**ADDENDUM #6**  
May 2, 2022

**TO:** ALL MANDATORY Pre-Bid Meeting Attendees  
**PROJECT NAME:** Contract 76 B.1-Biological Foul Air Mitigation System-Construction-Rebid  
**BID REFERENCE #:** 91359-003.0  
**BID DUE/OPENING DATE:** May 10, 2022 @ 3:30 p.m. Local Time

**Contract 76 B.1-Biological Foul Air Mitigation  
System-Construction-Rebid**

#### ***Approx. HMA Replacement Limits***

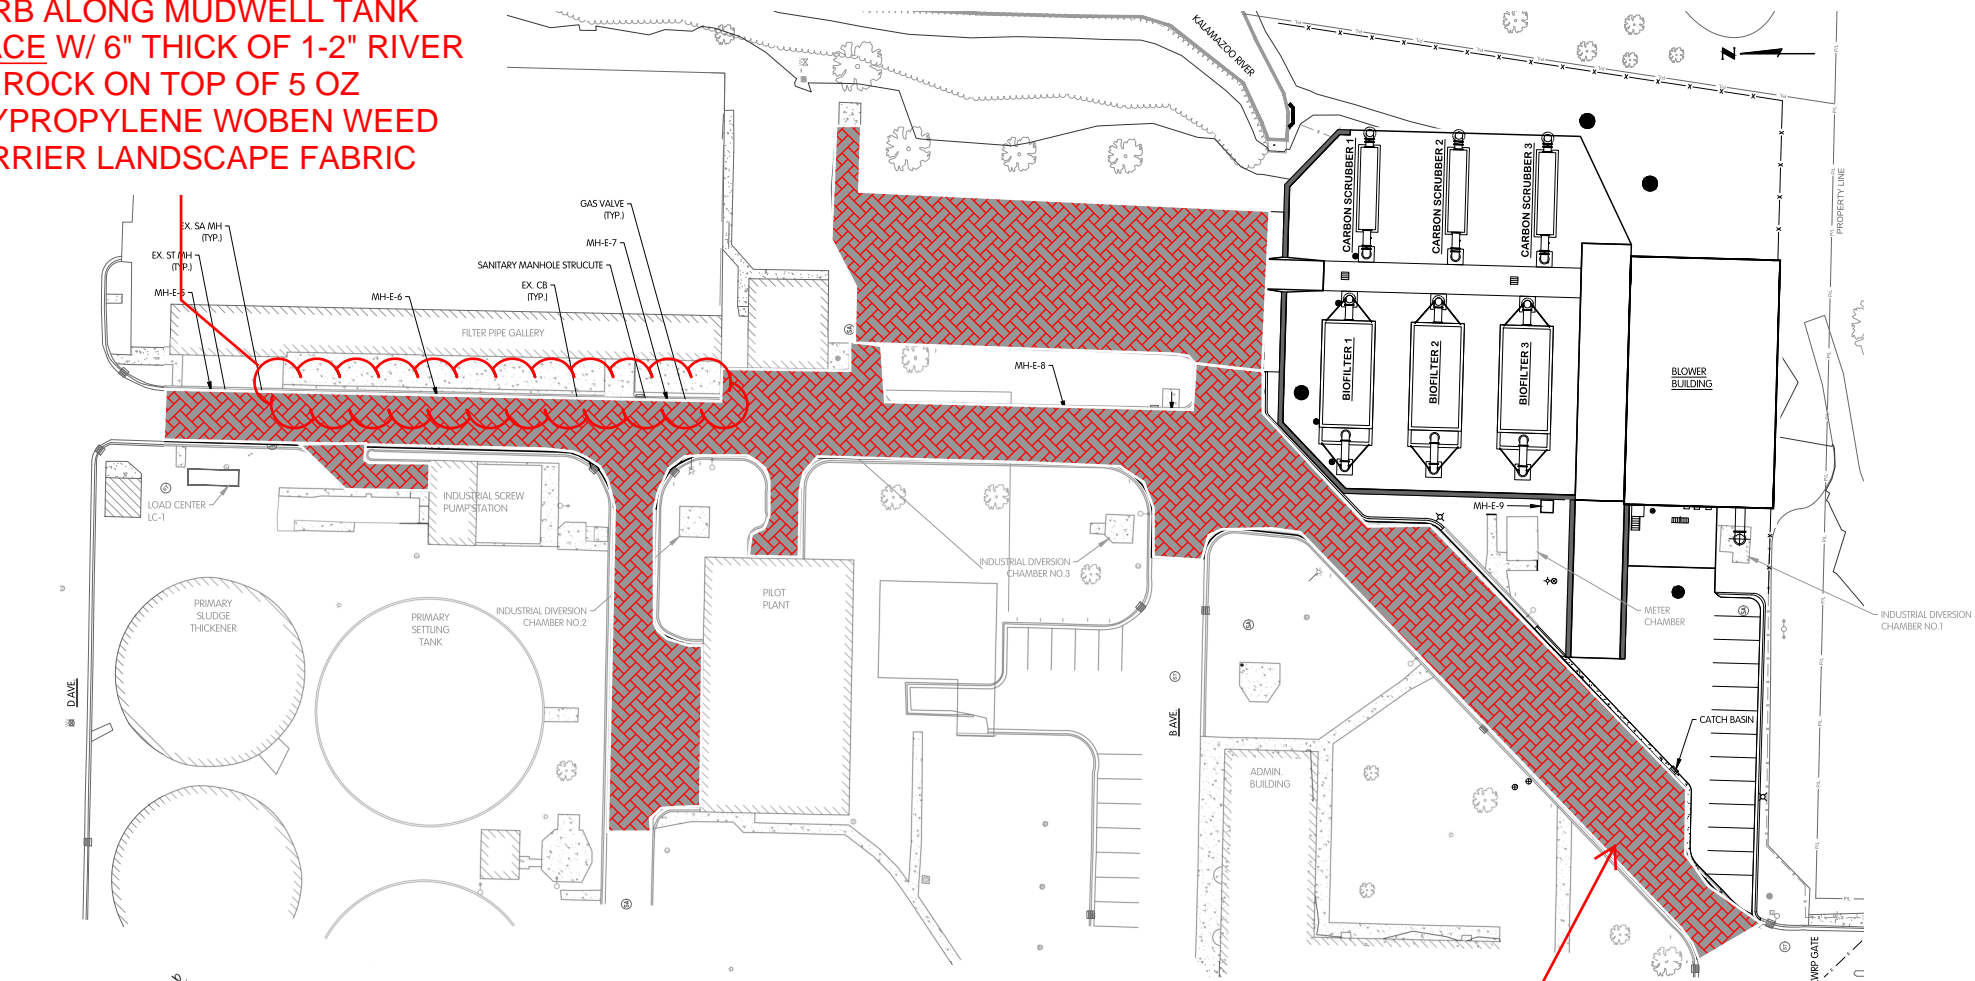
**Q1: Please clarify the milling depth for the areas to be milled and capped.**

REMOVE EXISTING SIDEWALK BEHIND  
CURB ALONG MUDWELL TANK  
REPLACE W/ 6" THICK OF 1-2" RIVER  
ROCK ON TOP OF 5 OZ  
POLYPROPYLENE WOBEN WEED  
BARRIER LANDSCAPE FABRIC

APPROX. HMA REPLACEMENT LIMITS  
REPLACE DAMAGED CURB  
REPLACE DAMAGED EXISTING CB INLET CASTING  
ADJUST CASTINGS AS NECESSARY  
OWNER WILL RE-STRIPE PARKING AREAS

A: Details regarding the milling specifications have been provided in *Addendum #6, Attachment C* and *Addendum #6, Attachment D*.

**TYPICAL REPLACEMENT HMA ROADWAY / PARKING LOT DETAIL**

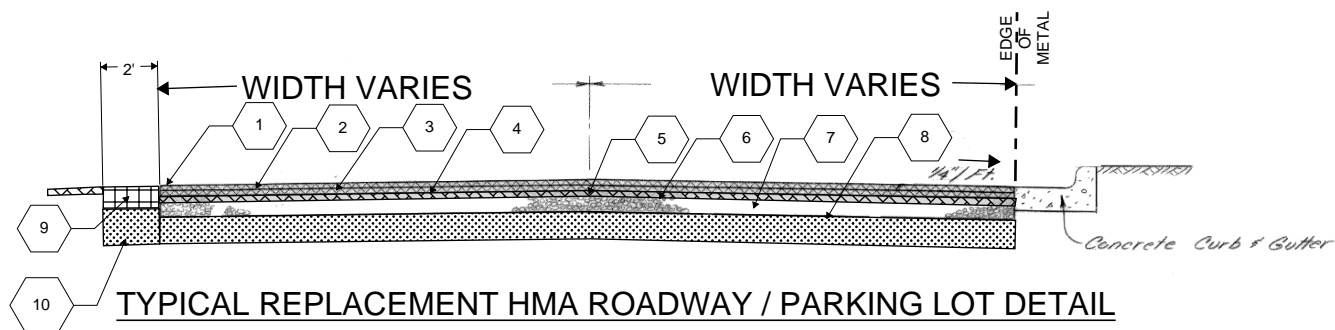
- 1 - 1 1/2" (165 LB/SQ YD) MDOT HMA 13A WEARING COURSE
- 2 - TACK COAT 0.05 GAL / SQ YD
- 3 - 1 1/2" (165 LB/SQ YD) MDOT HMA 13A LEVELING COURSE
- 4 - TACK COAT 0.05 GAL / SQ YD
- 5 - 2" (200 LB/SQ YD) MDOT 3C BASE COURSE
- 6 - TACK COAT 0.10 GAL / SQ YD
- 7 - 8" COMPACTED IN PLACE MDOT 21AA AGGREGATE BASE
- 8 - 12" COMPACTED IN PLACE MDOT CLASS II GRANULAR MATERIAL SUBBASE
- 9 - 8" COMPACTED IN PLACE MDOT 21AA AGGREGATE SHOULDER
- 10 - 17" COMPACTED IN PLACE MDOT CLASS II GRANULAR MATERIAL BASE
